DOCKET ITEM # 13

ROUTE 1 TRANSITWAY

Issue: Approval of the design for the Route 1 Transitway consistent with the 2008 Transportation Master Plan and the Corridor A Transitway alignment amendment to the 1992 Transportation Master Plan	Planning Commission Hearing:	May 1, 2012
	City Council Hearing:	May 12, 2012
Staff: Susan Gygi, Department of Transportation & Environmental Planning (susan.gygi@alexandriava.gov) Jeffrey Farner, Department of Planning & Zoning (jeffrey.farner@alexandriava.gov)

Figure 4: Perspective of Pedestrian Crossing of Route 1

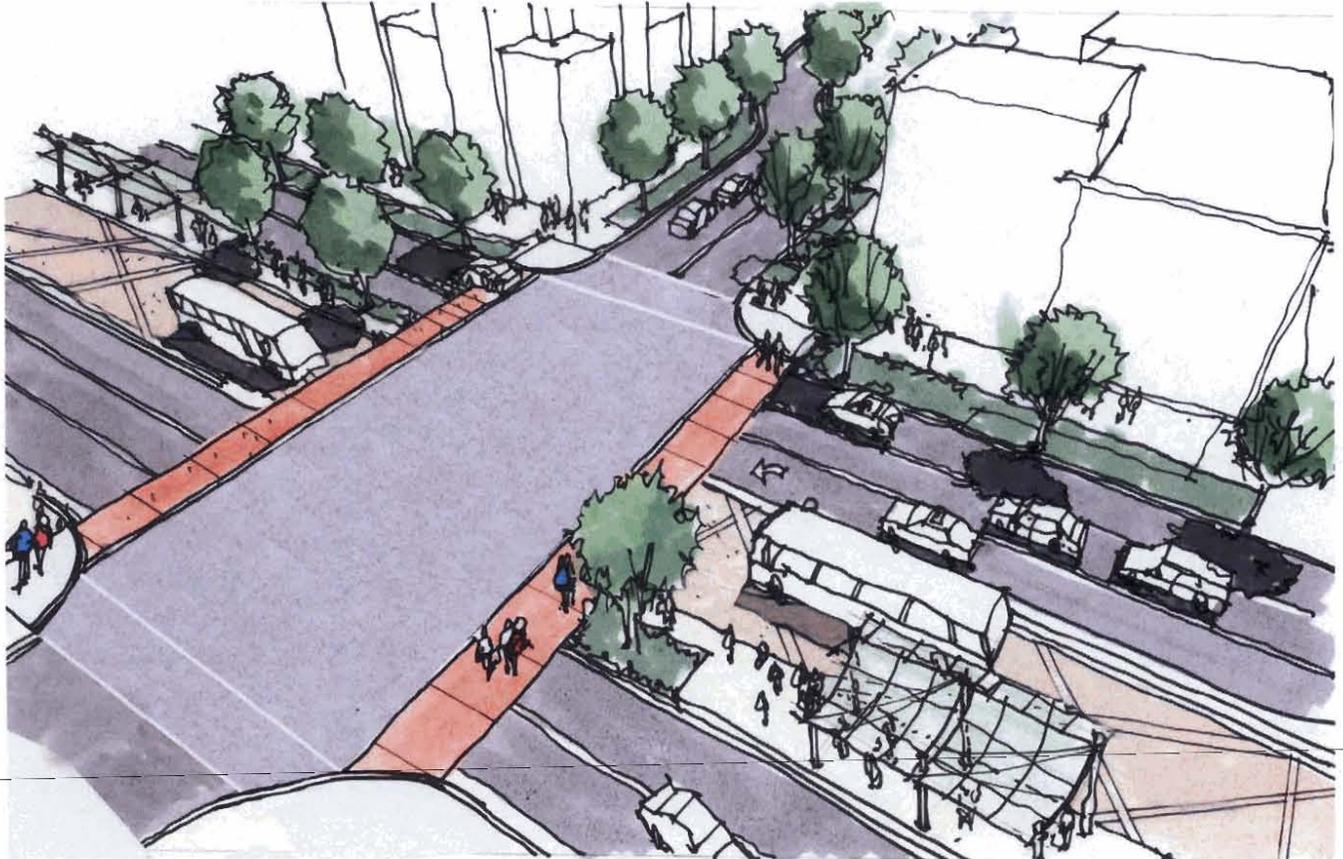
PLANNING COMMISSION ACTION, MAY 1, 2012: On a motion by Mr. Wagner, seconded by Ms. Fossum, the Planning Commission recommended approval of the Route 1 transitway design subject the staff recommendations and the following revisions as generally depicted in Figure 4:

1. Colored and textured concrete at each transit stop;
2. Colored and textured concrete for each pedestrian crosswalk on Route 1; and
3. The final design of the transit stations (shelters) will be subject to future review by the Planning Commission.

4. The transit station areas and pedestrian crosswalks shall be designed to include the following as generally depicted in Figure 4:
 - a. Colored and textured concrete at each transit stop;

- b. Colored and textured concrete for each pedestrian crosswalk on Route 1; and
5. The final design of the transit stations (shelters) will be subject to future review by the Planning Commission.

Figure 5: Proposed Landscape and Water Treatment Facility in west median along transitway between Maskill and Howell

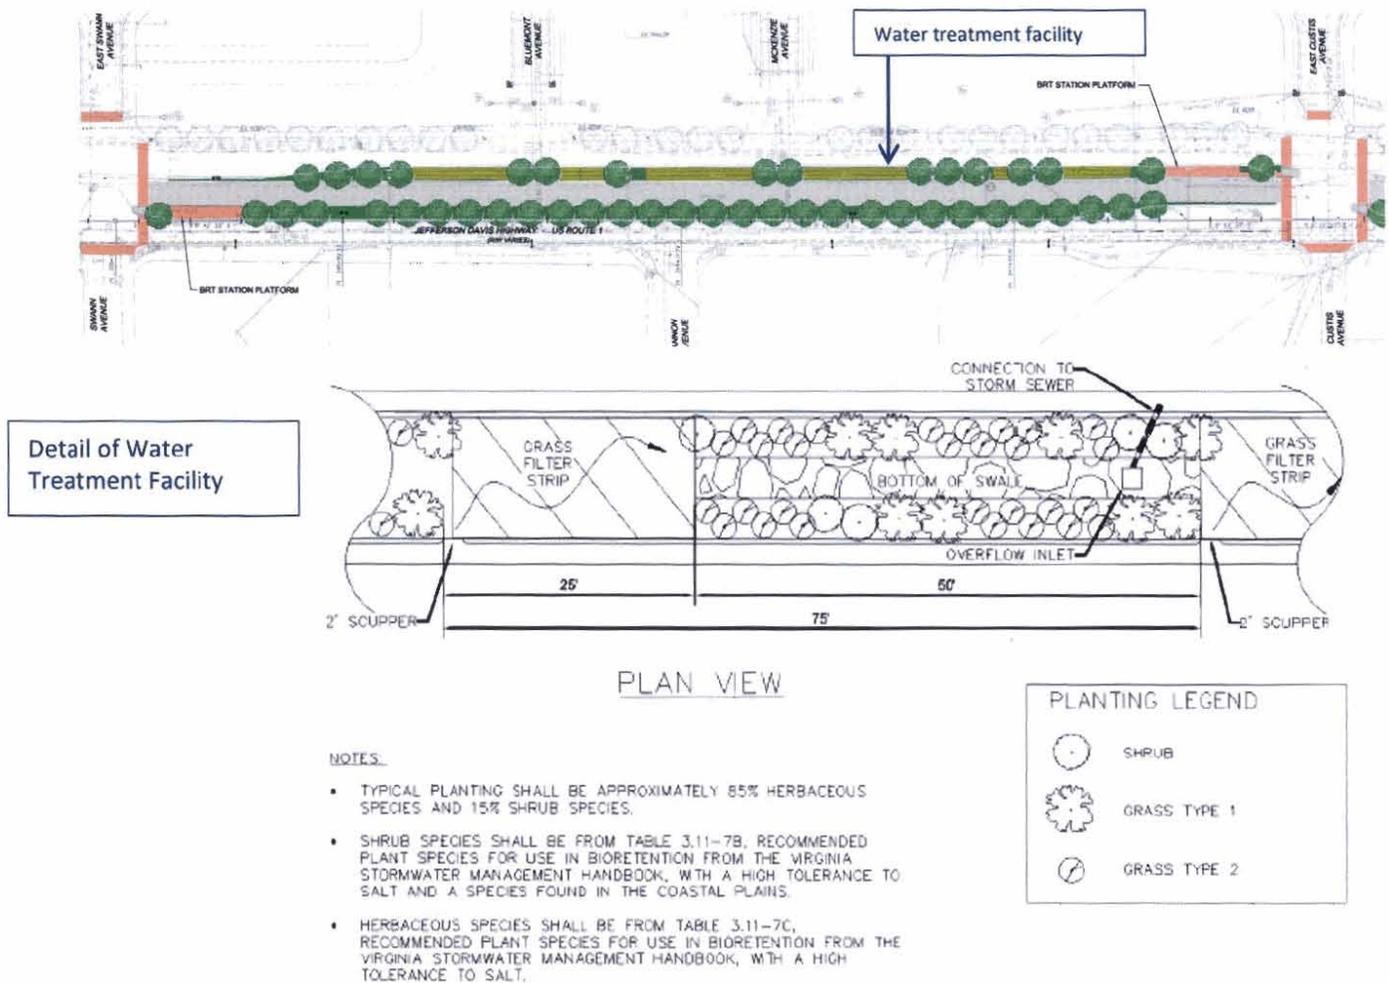
8. Stormwater facilities will be included in the design between Maskill Avenue and Howell Avenue. The specific design is under consideration. If possible, the cadence of trees along the east median will be maintained as generally depicted in **Figure 5**.
